SECTION 96 SUBMISSION

DEE WHY RSL CLUB - 932 PITTWATER ROAD  
STAGE 5 CLUB EXTENSION

DRAWING TITLE:  
**CLUB LEVEL 3 AND LEVEL 4 -  
EXISTING AND DEMOLITION PLAN**

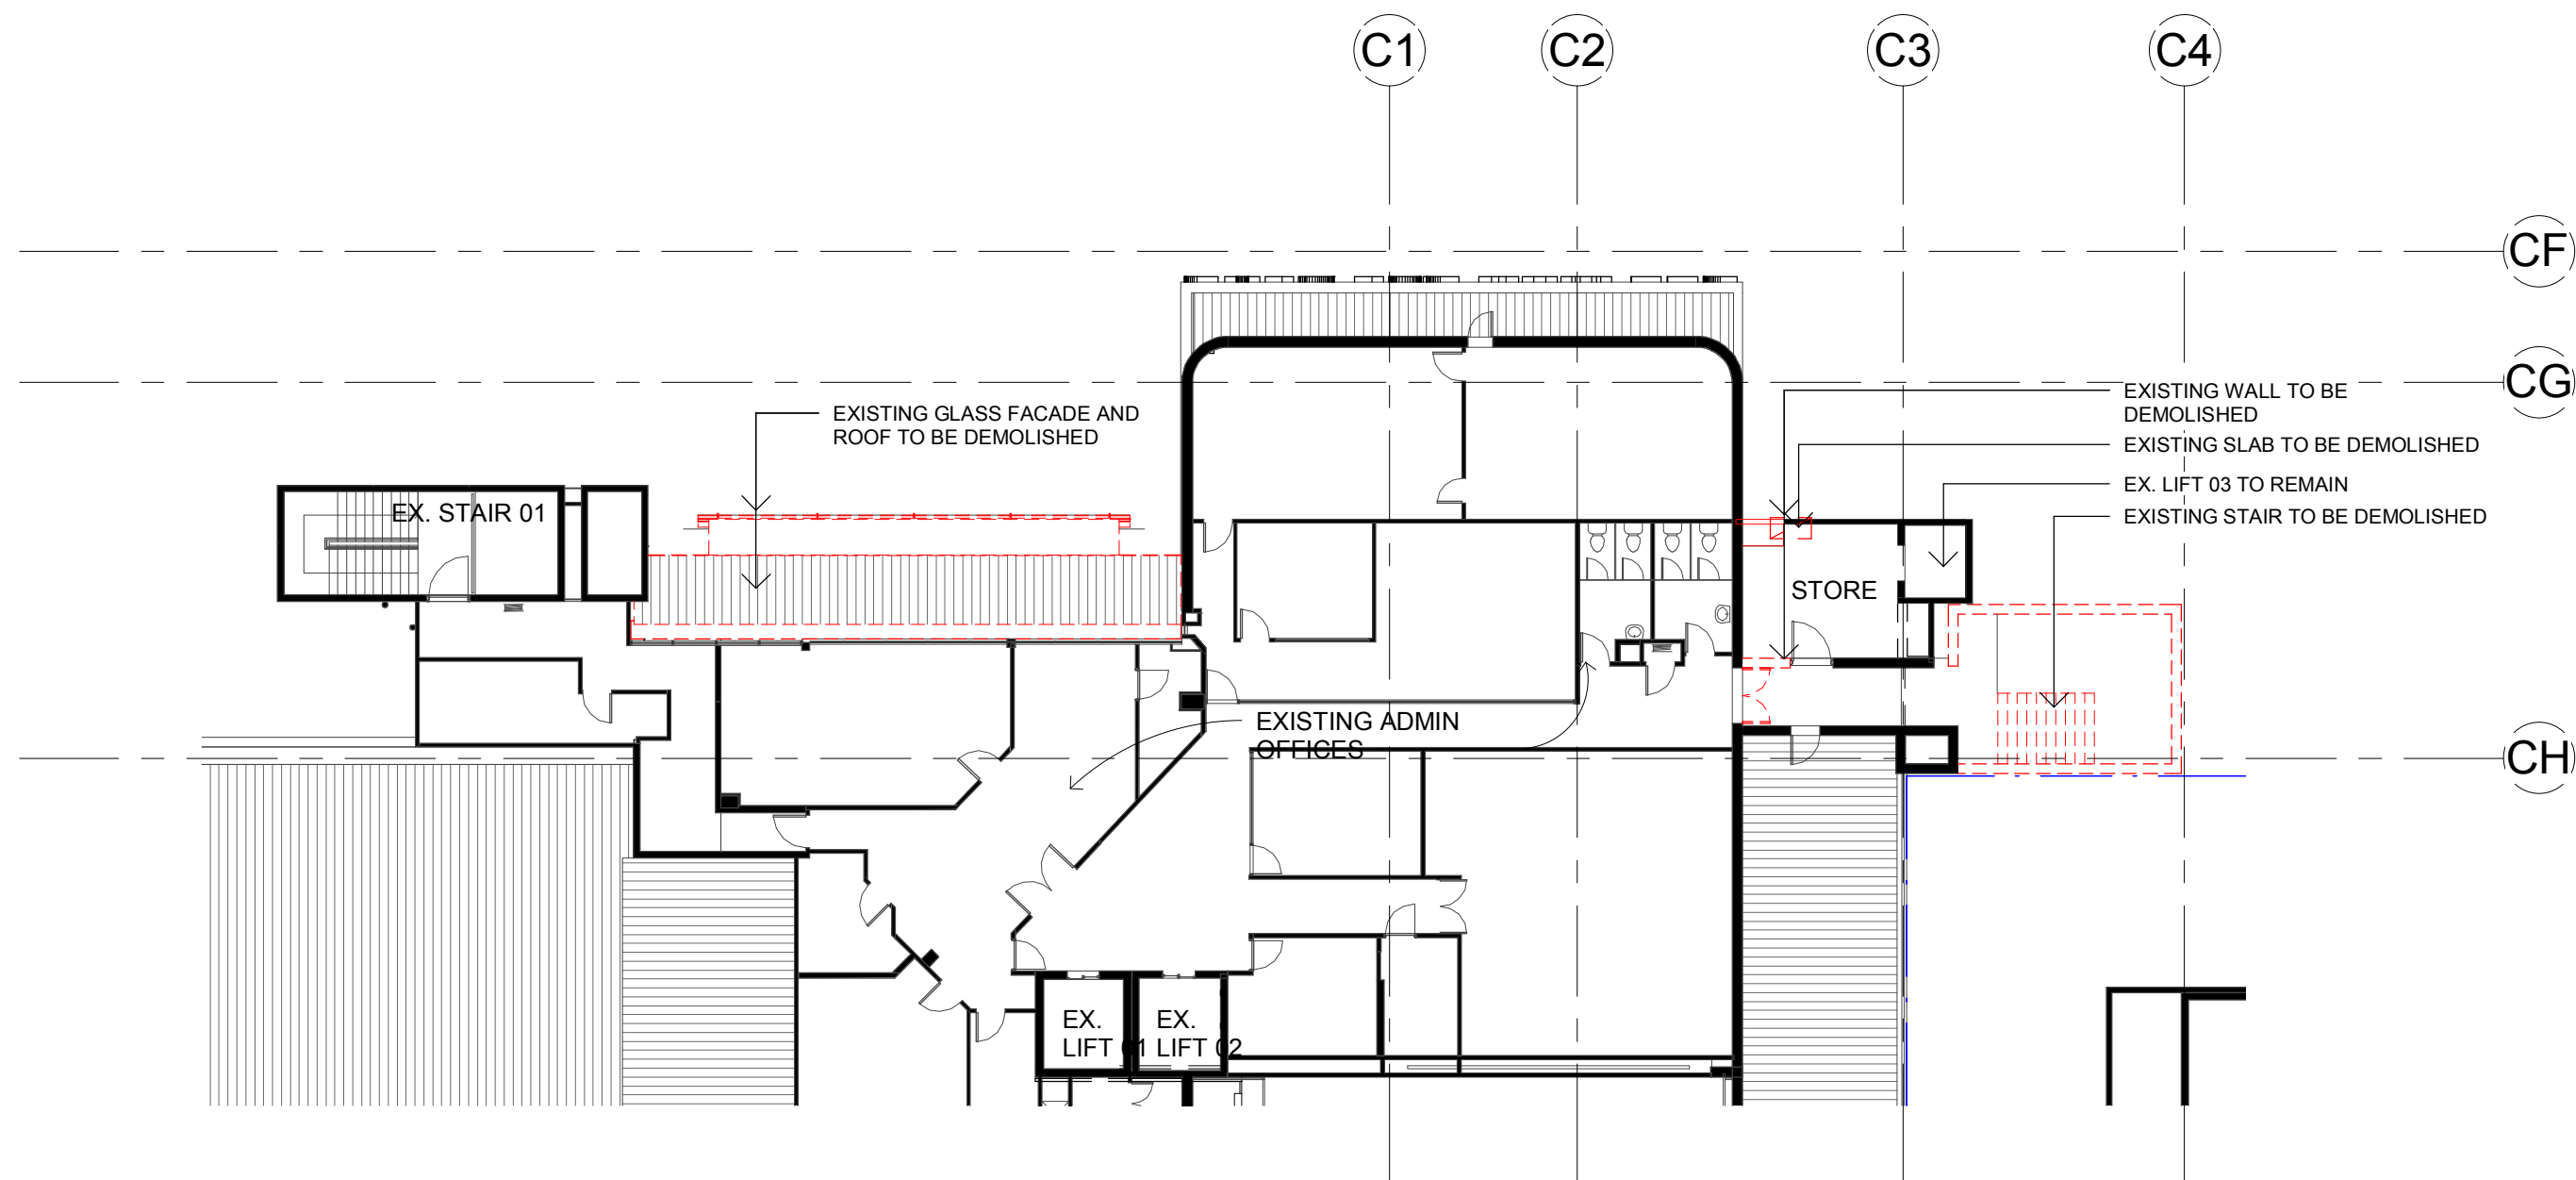
- CHANGES FOR SECTION 96 APPROVAL**
- roof
1. RELOCATED OPEN PLANTROOM AT THE ROOF LEVEL
  2. MODIFIED ROOF OPENING ABOVE MAIN ENTRANCE
  3. MODIFIED CENTRAL SKYLIGHT (REDUCED HEIGHT, MODIFIED PITCH)

4. MODIFIED COURTYARD: TWO OPEN COURTYARDS AND ONE SKYLIGHT COVERED AREA INSTEAD OF ONE LARGE GLASS ROOF, REDUCED HEIGHT AND PITCH
  5. MODIFIED SMOKING TERRACE: ROOF OPENING, SIZE AND PLANTED AREA. AREA REDUCED BY 21m<sup>2</sup>

6. REDUCED NUMBER OF ROOF SKYLIGHTS ABOVE ASIAN RESTAURANT: 2 INSTEAD OF 6 TO SUIT THE NEW INTERNAL LAYOUT
  7. MODIFIED EXIT STAIR: POSITION, CONFIGURATION, METAL ROOF NO LONGER REQUIRED

10. NEW ACOUSTIC METAL ROOF ABOVE REVISED LOADING DOCK
- facade
11. MODIFIED FACADE APPEARANCE DUE TO CHANGES IN THE CAR PARK LEVELS, LOADING DOCK AND EGRESS STAIRS

12. REMOVED LOUVRES ON THE BACK FACADE (WESTERN FACADE) DUE TO MECHANICAL RISER NO LONGER REQUIRED / REVISED LOCATION FOR EGRESS DOORS
  13. 2m WIDE INTERNAL EGRESS STAIR MODIFIED INTO TWO 1m WIDE EXTERNAL STAIRS WITH DECORATIVE BALUSTRADES

14. EXTENT OF LEVEL 2 (MAIN TRADING LEVEL) REDUCED BY 6328mm FROM THE SOUTHERN BOUNDARY AND INCREASED BY 1100mm TO THE EASTERN BOUNDARY
  15. MODIFIED FACADE CURTAIN WALL MULLION BLADES

- ground/landscape/floor plate
18. REVISED LOADING DOCK ENTRANCE AND LOCATION/ENLARGED DEMOLISHED AREA IN THE EXISTING RETAINED SOUTHERN CAR PARK
  19. NEW / MODIFIED EGRESS PATHS FROM EXISTING CARPARK LEVEL -1. NEW CARPARK LEVEL 1.

20. RELOCATED ELECTRICAL SUBSTATION / LANDSCAPED AREA MOVED TO SUIT
  21. MEDIAN STRIP ADDED AT ENTRY TO PROVIDE PLACE OF REFUGE AND ENSURE WIDTH OF ENTRY/ EXIT IS LESS THAN 8M AS PER DA CONDITION 23

24. BASEMENT CAR PARK LEVEL -5 ADDED.
  25. CAR PARK ENTRY / EXIT MOVED TOWARD NORTH BY 3044mm
  26. PLANTER MODIFIED ON THE BACK (WESTERN) FACADE DUE TO REDUCTION OF THE MAIN TRADING FLOOR SLAB

27. LOCATION OF AIR INTAKE MODIFIED
  28. EXTENT OF RESTAURANT REDUCED BY 136m<sup>2</sup>
  29. CLUB ENTRANCE ACCESSIBLE RAMPS MODIFIED
  30. ONE ADDITIONAL EXISTING CAR PARK SPACE TO BE REMOVED FROM EXISTING NORTHERN CAR PARK

31. SOLID MASONRY WALL ADDED BETWEEN EXISTING ZONE D CAR PARK AND LOADING DOCK ACCESS.

1 CAR PARK LEVEL -5  
Scale: 1: 200

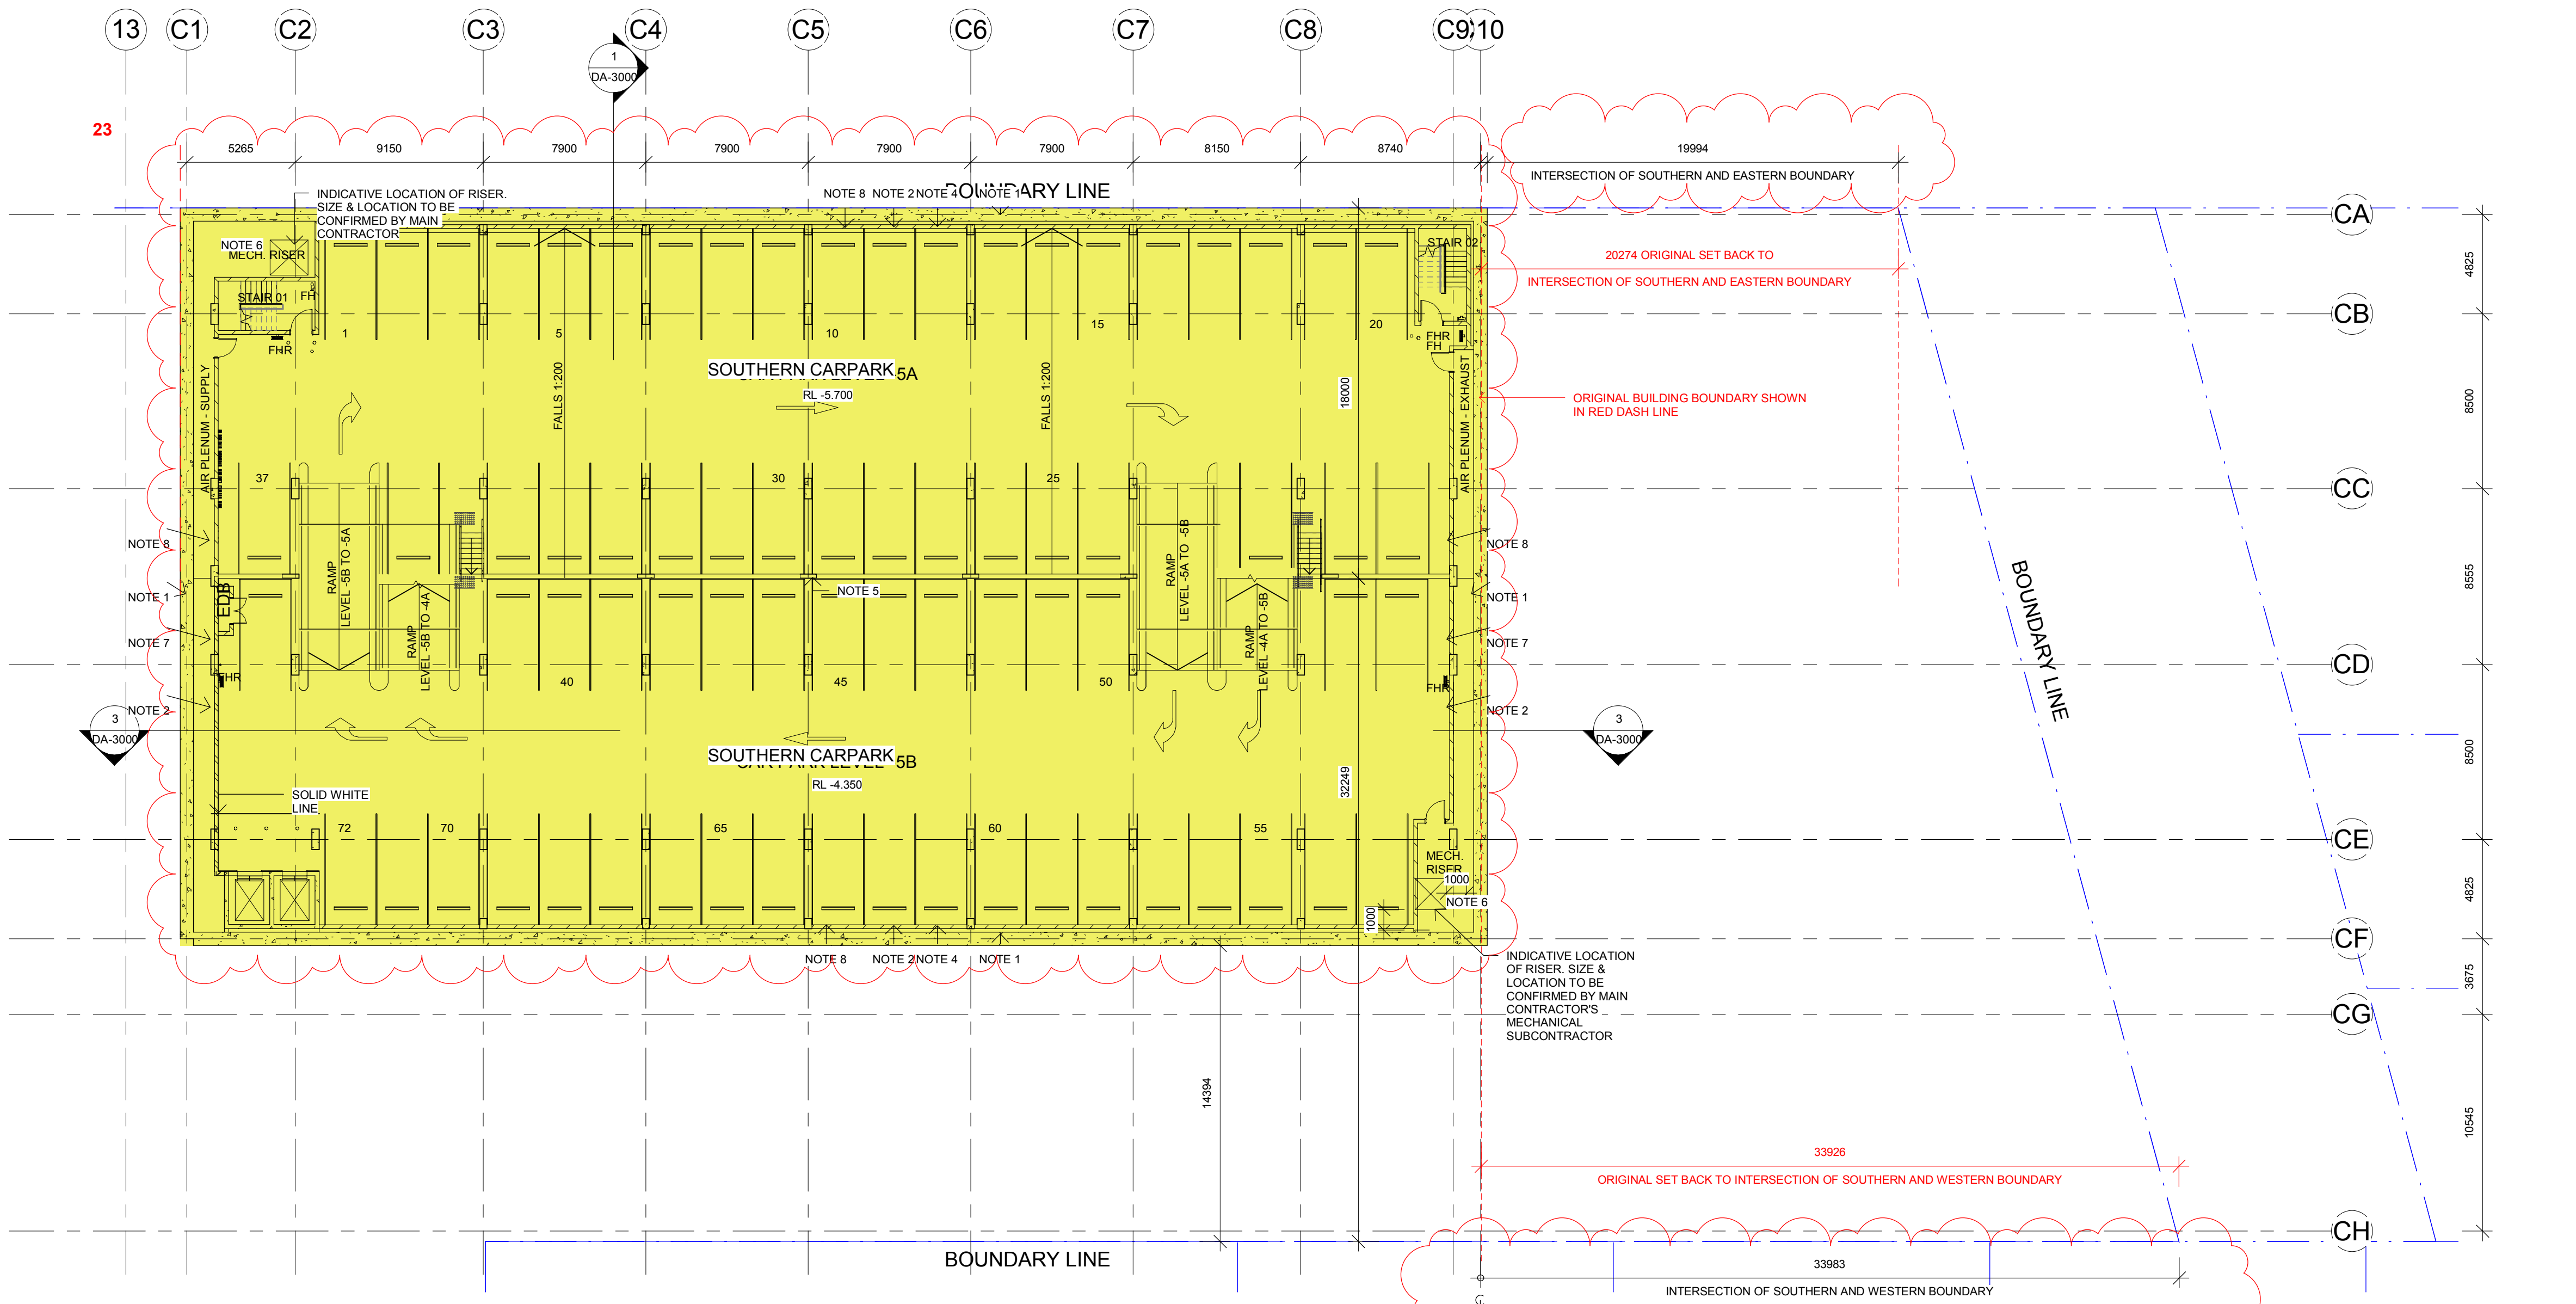
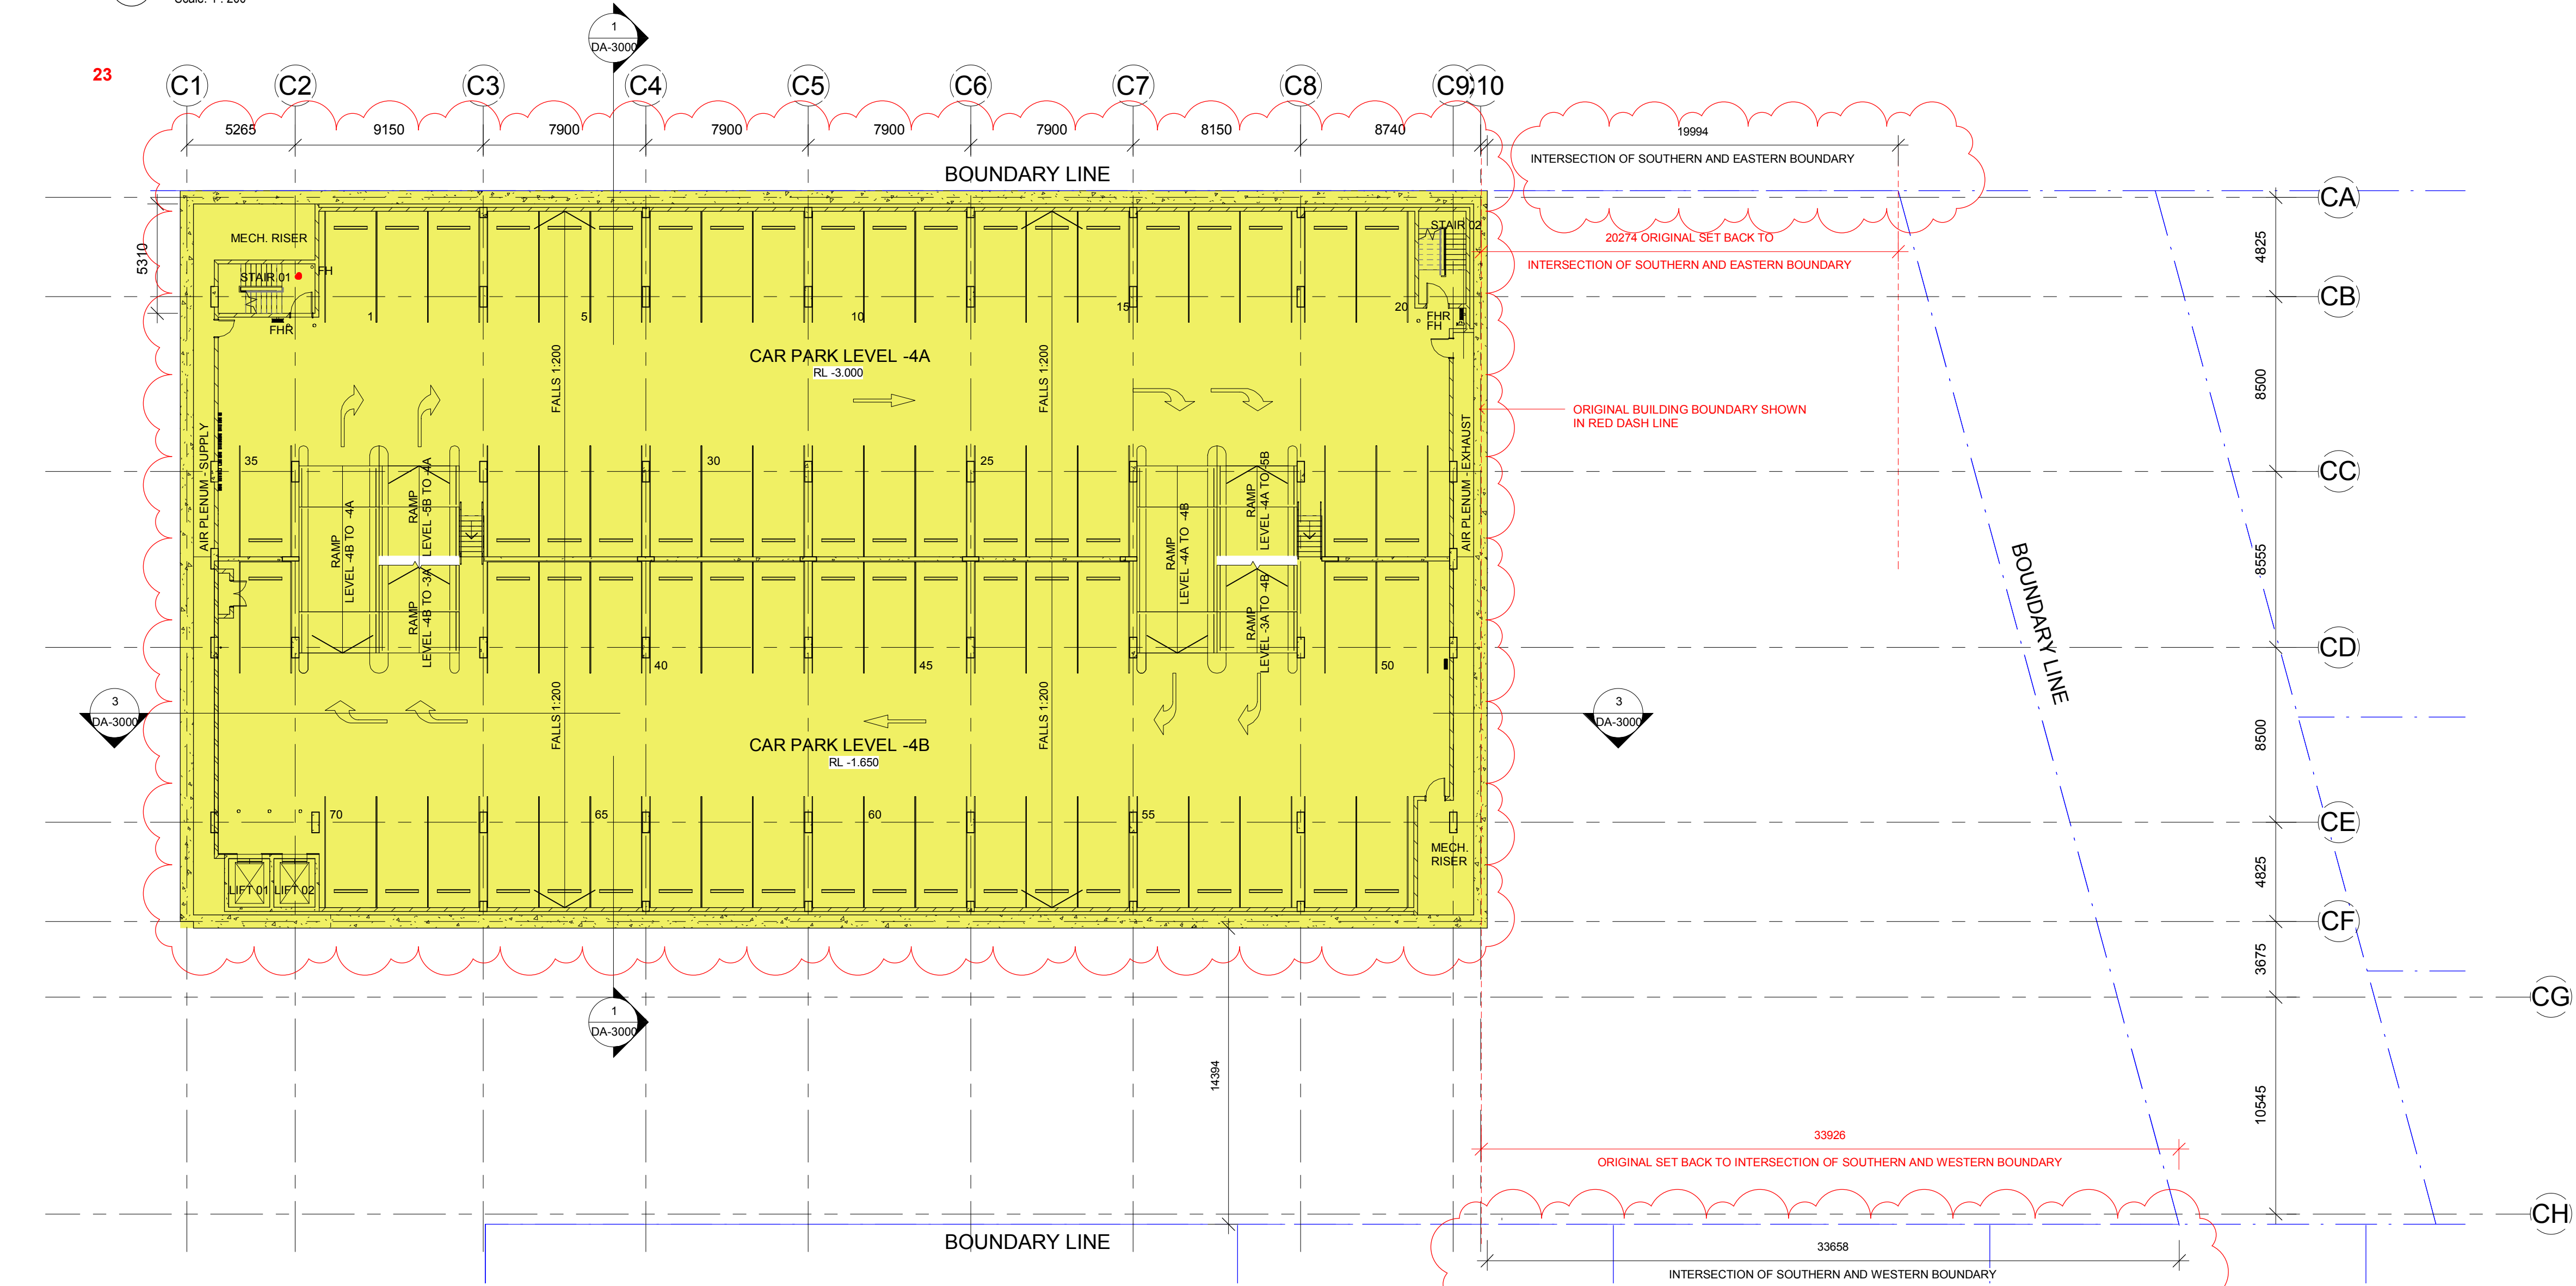
1. RELOCATED OPEN PLANTROOM AT THE ROOF LEVEL  
2. MODIFIED ROOF OPENING ABOVE MAIN ENTRANCE  
3. MODIFIED CENTRAL SKYLIGHT (REDUCED HEIGHT, MODIFIED PITCH)  
4. MODIFIED COURTYARD: TWO OPEN COURTYARDS AND ONE SKYLIGHT COVERED AREA INSTEAD OF ONE LARGE GLASS ROOF. REDUCED HEIGHT AND PITCH  
5. MODIFIED SMOKING TERRACE: ROOF OPENING, SIZE AND PLANTED AREA. AREA REDUCED BY 21m²  
6. REDUCED NUMBER OF ROOF SKYLIGHTS ABOVE ASIAN RESTAURANT. 2 INSTEAD OF 6 TO SUIT THE NEW INTERNAL LAYOUT  
7. MODIFIED EXIT STAIR: POSITION, CONFIGURATION, METAL ROOF NO LONGER REQUIRED  
8. CONCRETE ROOF INSTEAD OF METAL DECK ROOF FOR THE MAJORITY OF THE BUILDING EXTENSION  
9. NO SLAB ABOVE THE EXPOSED CAR PARK LEVEL 2 IN THE SOUTH AREA  
10. NEW ACOUSTIC METAL ROOF ABOVE REVISED LOADING DOCK

11. MODIFIED FACADE APPEARANCE DUE TO CHANGES IN THE CAR PARK LEVELS, LOADING DOCK AND EGRESS STAIRS  
12. REMOVED LOUVRES ON THE BACK FACADE (WESTERN FACADE) DUE TO MECHANICAL RISER NO LONGER REQUIRED / REVISED LOCATION FOR EGRESS DOORS  
13. 2m WIDE INTERNAL EGRESS STAIR MODIFIED INTO TWO 1m WIDE EXTERNAL STAIRS WITH DECORATIVE BALUSTRADES  
14. EXTENT OF LEVEL 2 (MAIN TRADING LEVEL) REDUCED BY 532mm FROM THE SOUTHERN BOUNDARY AND INCREASED BY 1100mm TO THE EASTERN BOUNDARY  
15. MODIFIED FACADE CURTAIN WALL MULLION BLADES  
16. CONCRETE BLADE WALL REDUCED BY 1.47m IN HEIGHT AND 6.2m IN LENGTH  
17. VERTICAL FINS REMOVED FROM BACK WALL (WESTERN FACADE)

18. REVISED LOADING DOCK ENTRANCE AND LOCATION/ ENLARGED DEMOLISHED AREA IN THE EXISTING RETAINED SOUTHERN CAR PARK  
19. NEW / MODIFIED EGRESS PATHS FROM EXISTING CARPARK LEVEL -1. NEW CARPARK LEVEL 1.

20. RELOCATED ELECTRICAL SUBSTATION / LANDSCAPED AREA MOVED TO SUIT  
21. MEDIAN STRIP ADDED AT ENTRY TO PROVIDE PLACE OF REFUGE AND ENSURE WIDTH OF ENTRY/ EXIT IS LESS THAN 8M AS PER DA CONDITION 23

24. BASEMENT CAR PARK LEVEL -5 ADDED.  
25. CAR PARK ENTRY / EXIT MOVED TOWARD NORTH BY 30444mm  
26. PLANTER MODIFIED ON THE BACK (WESTERN) FACADE DUE TO REDUCTION OF THE MAIN TRADING FLOOR SLAB

27. LOCATION OF AIR INTAKE MODIFIED  
28. EXTENT OF RESTAURANT REDUCED BY 136m²  
29. CLUB ENTRANCE ACCESSIBLE RAMPS MODIFIED  
30. ONE ADDITIONAL EXISTING CAR PARK SPACE TO BE REMOVED FROM EXISTING NORTHERN CAR PARK

31. SOLID MASONRY WALL ADDED BETWEEN EXISTING ZONE D CAR PARK AND LOADING DOCK ACCESS.
